**City of Ramsey**  
**Agenda**  
**Environmental Policy Board (EPB)**  
**Monday, October 20, 2025**  
**6:30 pm**  
**Council Chambers, 7550 Sunwood Drive NW**

Consider Natural Resources Aspects of a Site Plan for CorTrust Bank (Project No. 25-123); Case of CorTrust Bank

**CORTRUST BANK**  
RAMSEY, MINNESOTA

## 1 - Exterior Materials

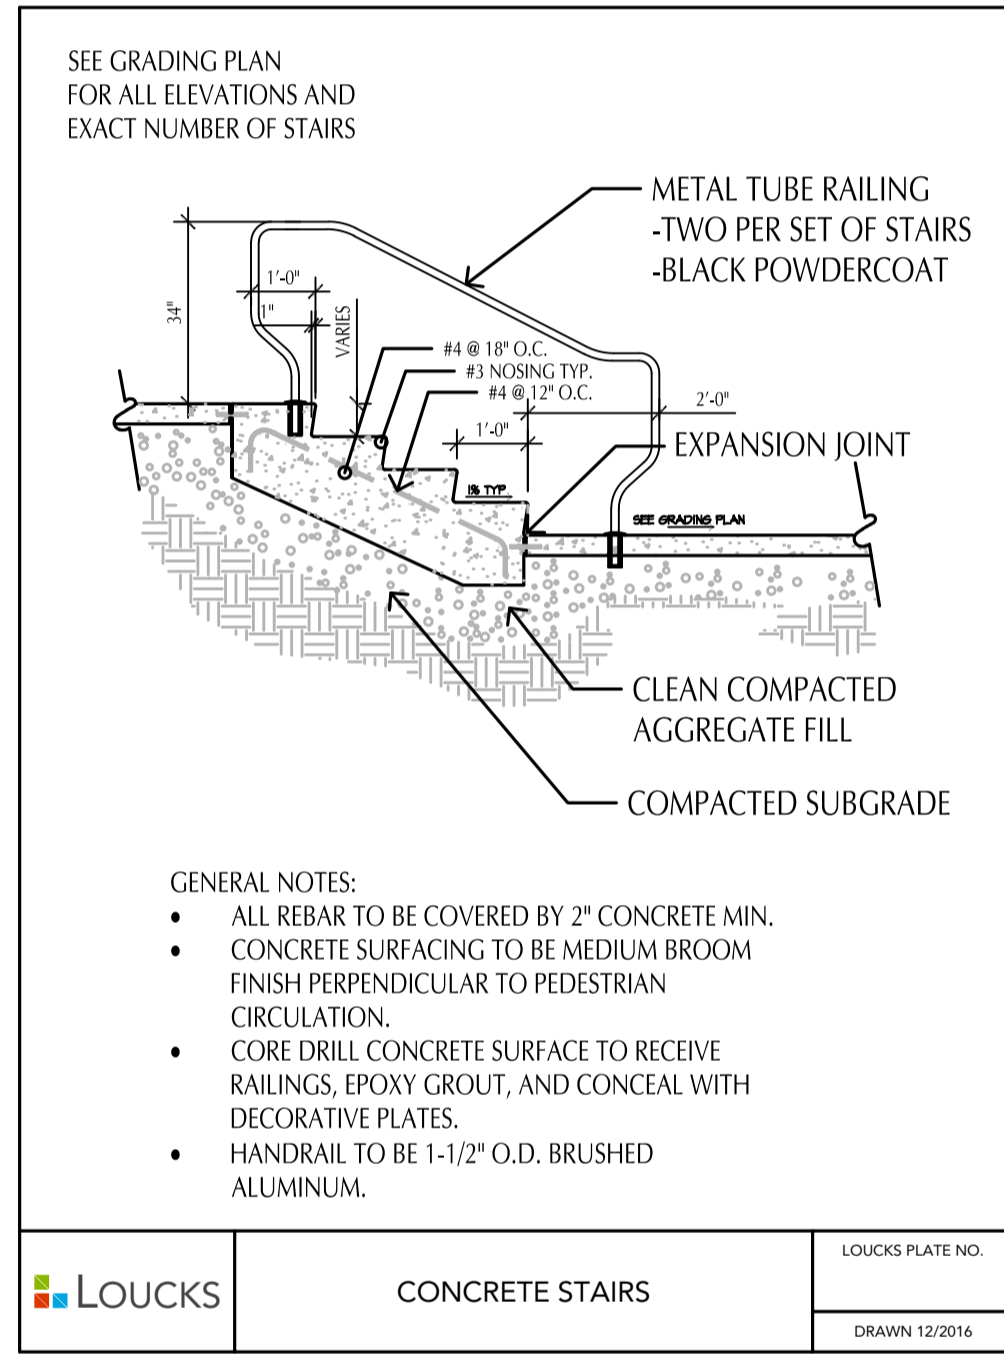
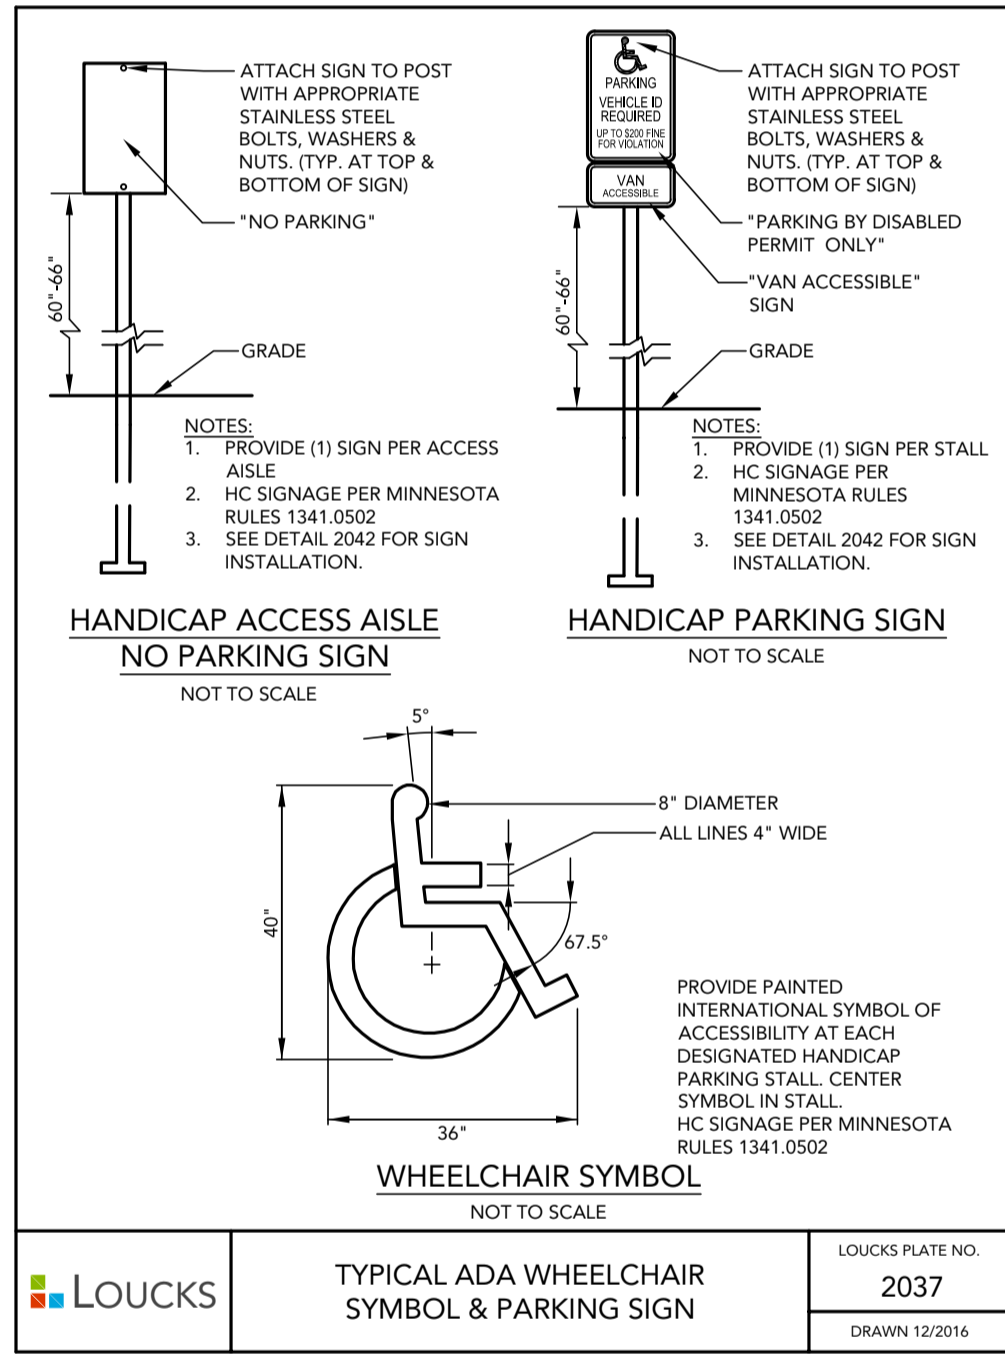
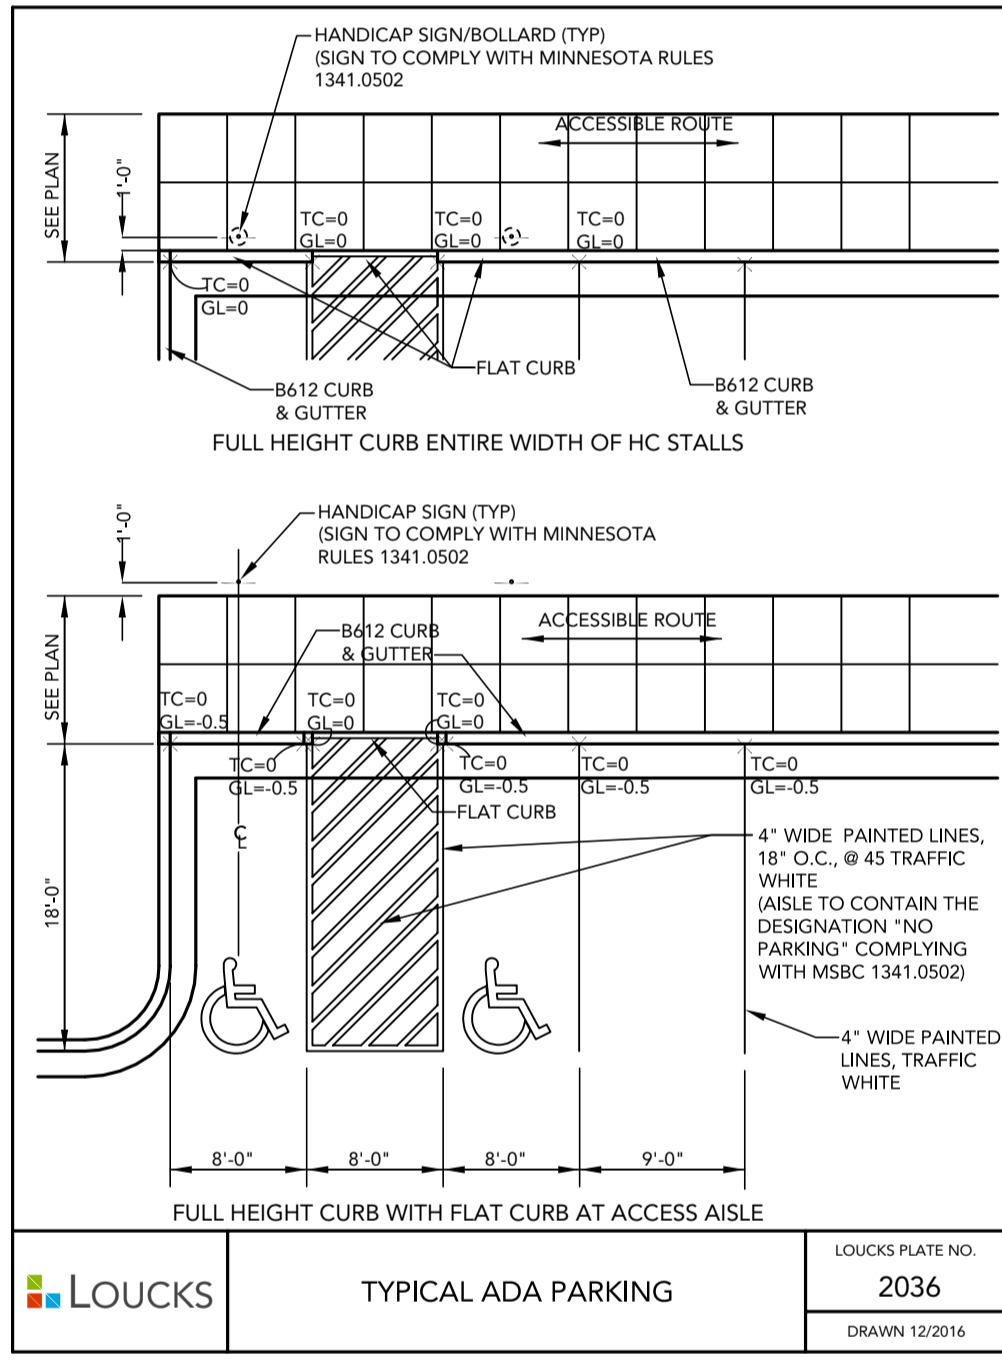
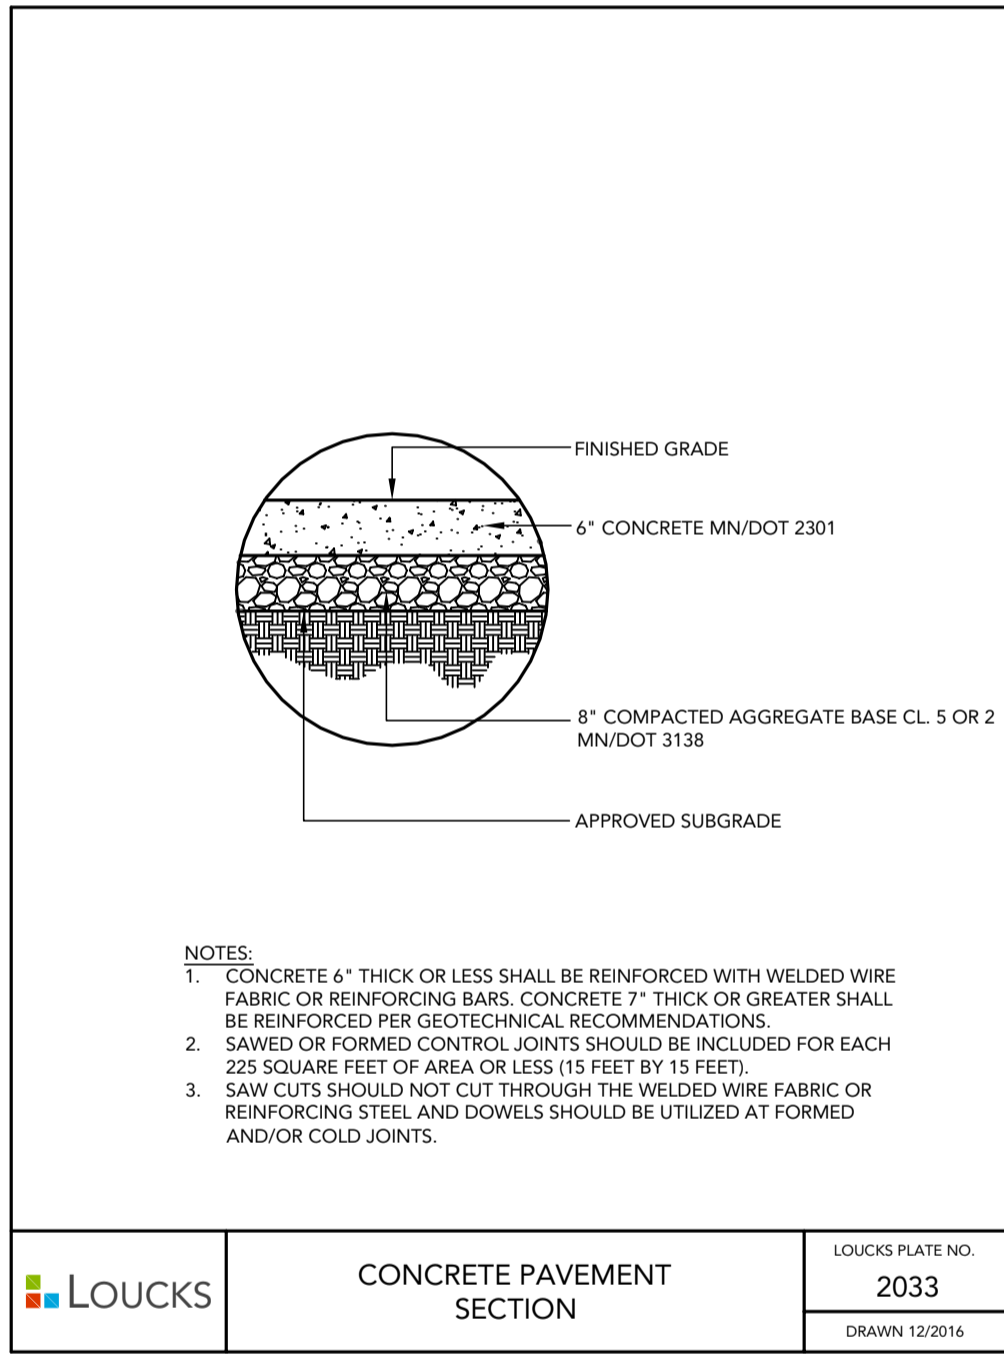
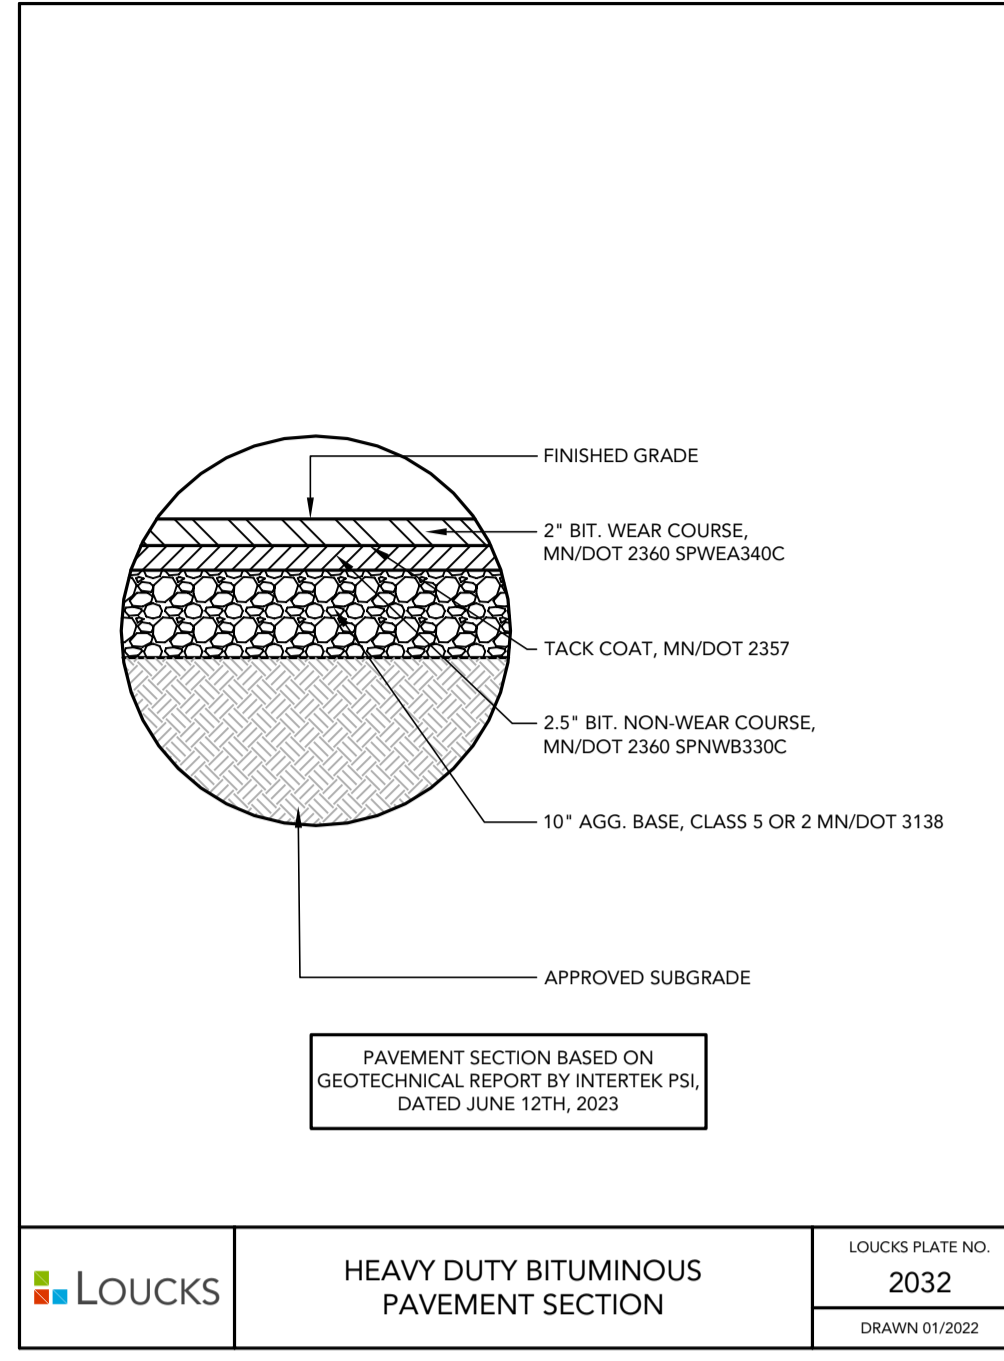
The exterior finish of this wall appears different from the exterior finish of the building. Can you please provide additional information on how the materials will compliment one another?

Also, the minimum height of the wall shall be three (3) feet and the maximum height shall not exceed 4.5 feet.
